## Technical Note 03

<b>Project</b>	Chediston Street, Halesworth	<b>Prepared by:</b>	PF
<b>Project No:</b>	A13455	<b>Approved by:</b>	Victoria Balboa
<b>Client:</b>	Christchurch Land and Estates	<b>Status:</b>	Issue
<b>Subject:</b>	Proposed Access Junction	<b>Date:</b>	03/09/2020

**RE: Designers Response to Stage 1 Road Safety Audit - Land South of Chediston Street, Halesworth, Suffolk**

**Proposed Site Access Junction**

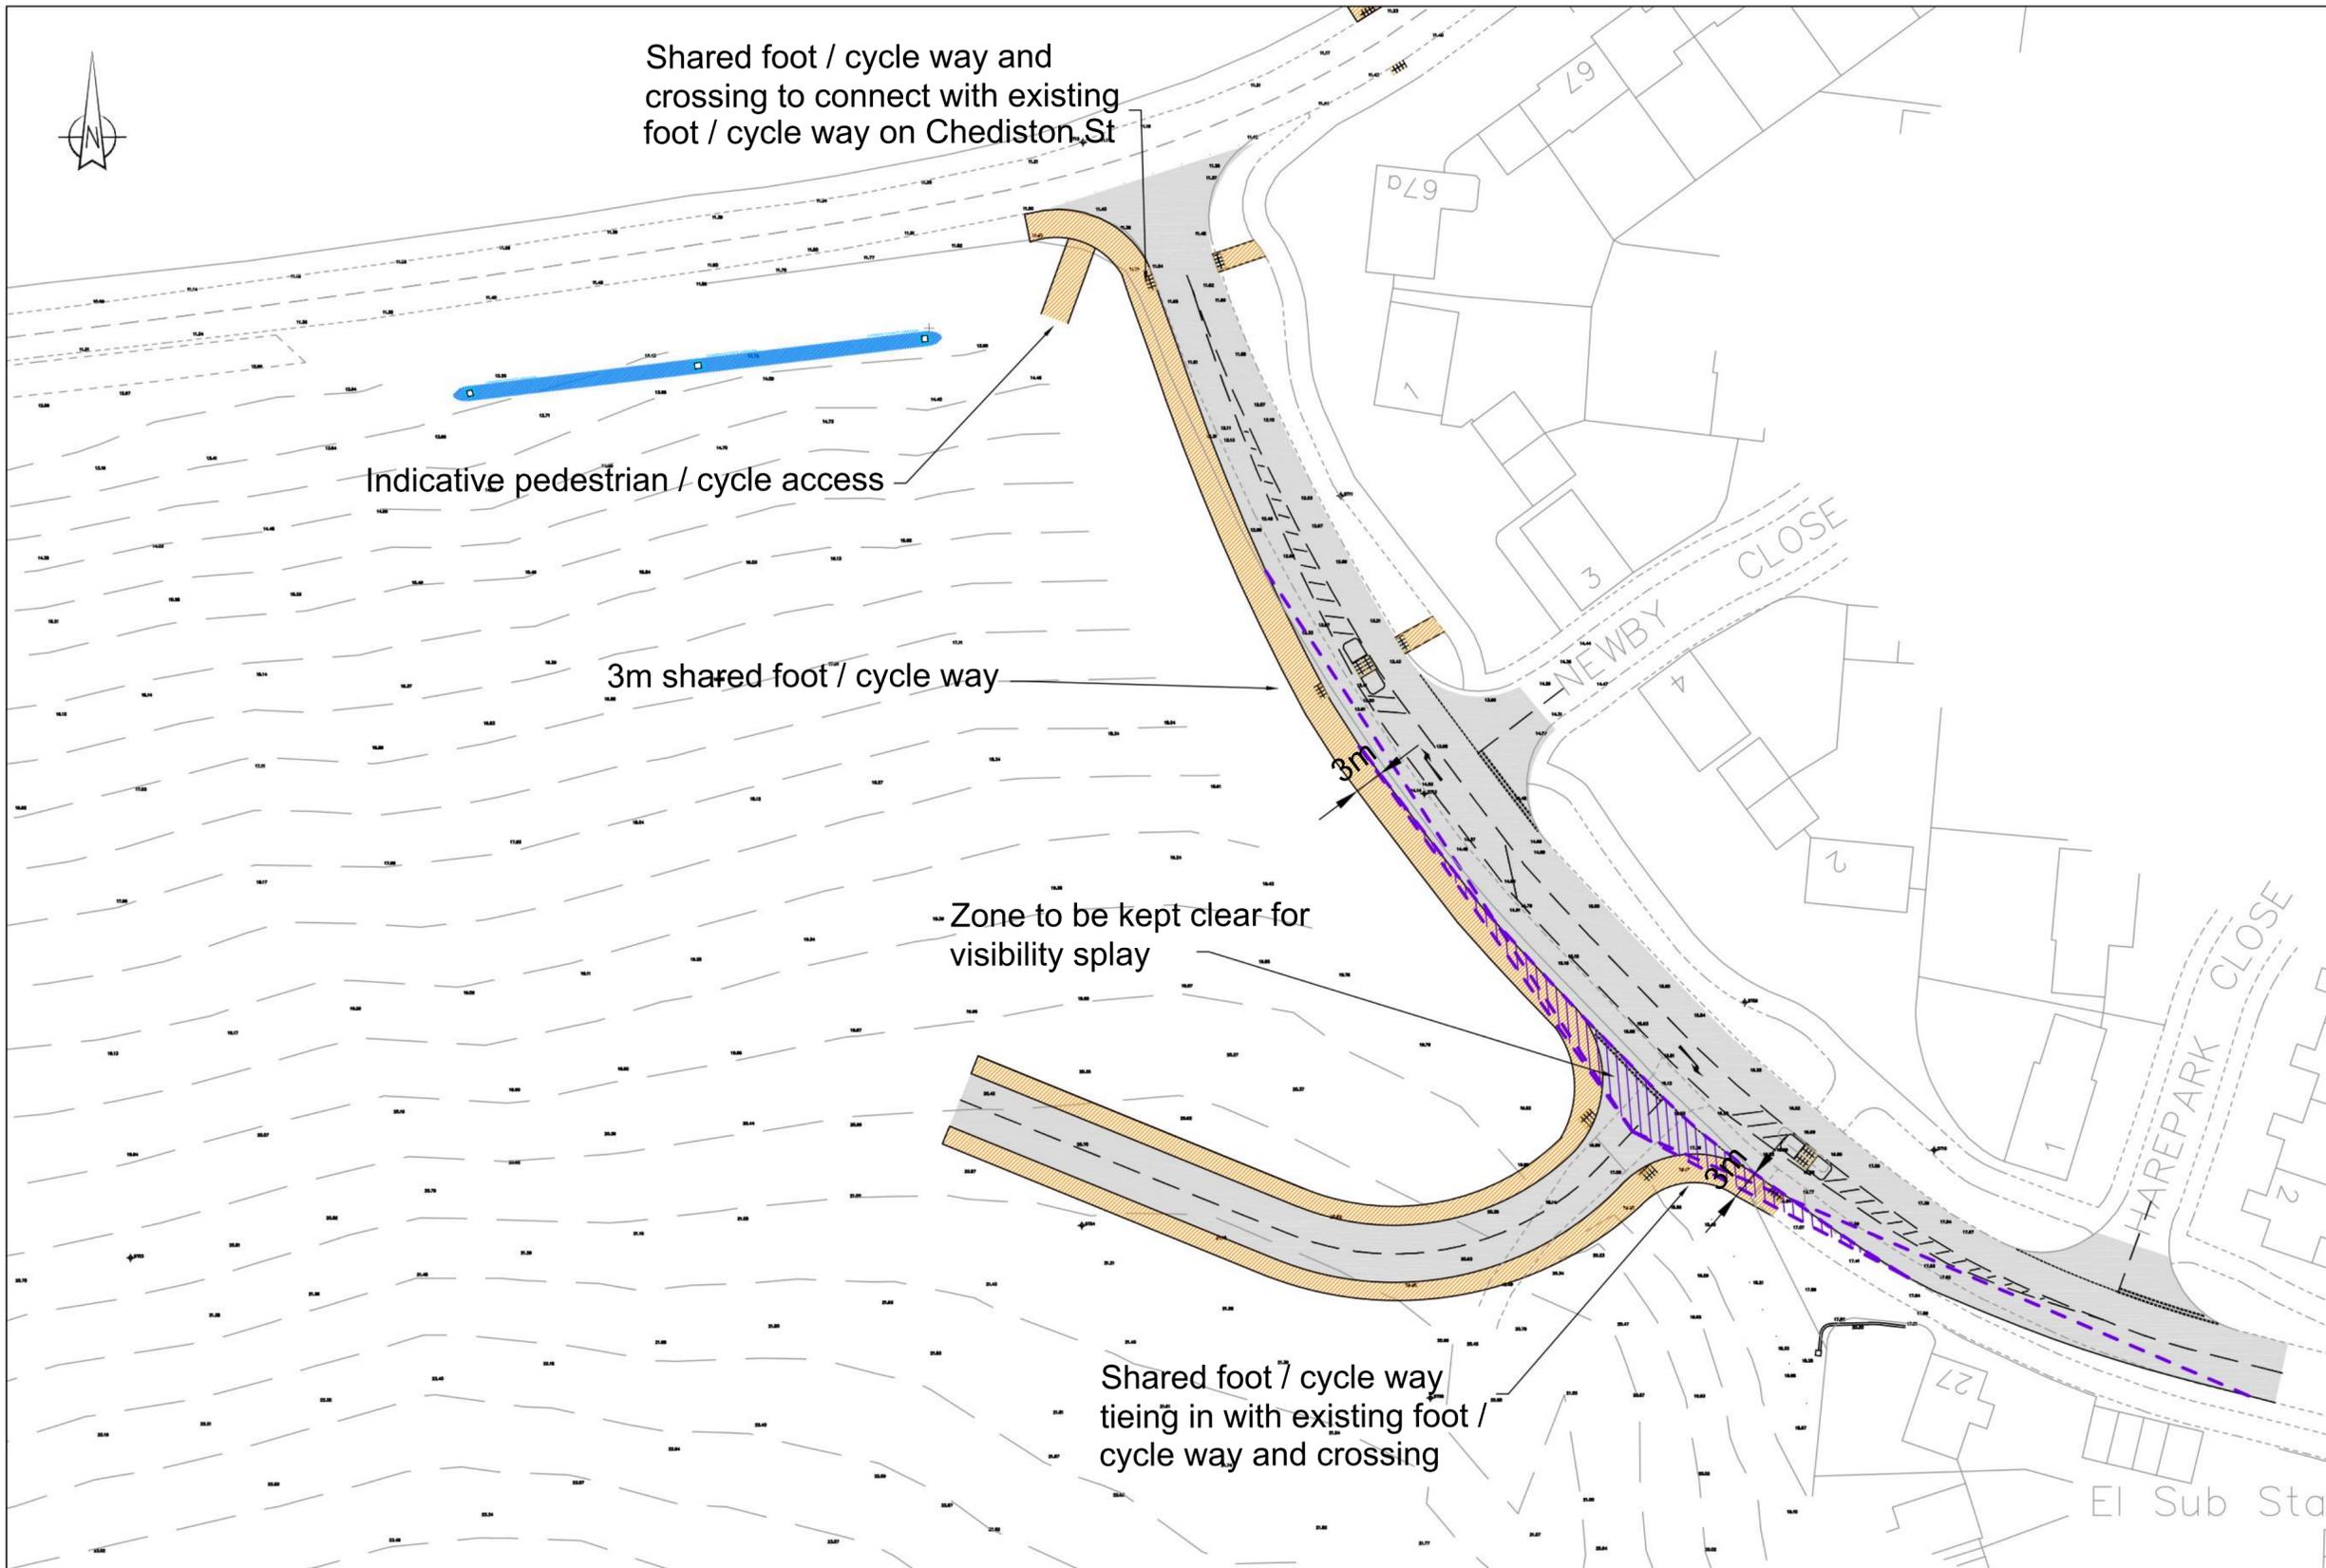
- 3.1 An independent Stage 1 Road Safety Audit was undertaken by a qualified, independent auditor. Minor issues were raised by the auditor and the proposed site access junction has been amended to address these issues. The revised drawing is provided in **Appendix A**. The independent auditor has confirmed in writing that the revised drawing addresses the minor issues raised, and this letter is provided in **Appendix B**.
- 3.2 The table below summarises the minor issues raised and how they have been addressed.

Issue Raised	Designer’s Response
Ensure adequate road drainage when new access is installed	This will be fully considered in the detailed design and agreed with the highway authority.
Ensure vegetation is cut back within visibility splay	This is part of routine highway maintenance
Ensure vehicles can pass at junction	Swept path analysis provided to demonstrate that vehicles can safely pass each other
Reduce the length of the central hatch markings	Road markings amended
Increase the length of the right turn storage area	Road markings amended
Ensure footways are of sufficient width	Dimensions provided
Move pedestrian crossing location at Roman Way/Chediston Street further north	Retained in current location as this provides a shorter crossing width; however can be reconsidered at detailed design stage
Provide dropped kerbs and tactile paving at site access	Drawing amended to include

Shared foot / cycle way and crossing to connect with existing foot / cycle way on Chediston St

Indicative pedestrian / cycle access

Shared foot / cycle way tying in with existing foot / cycle way and crossing
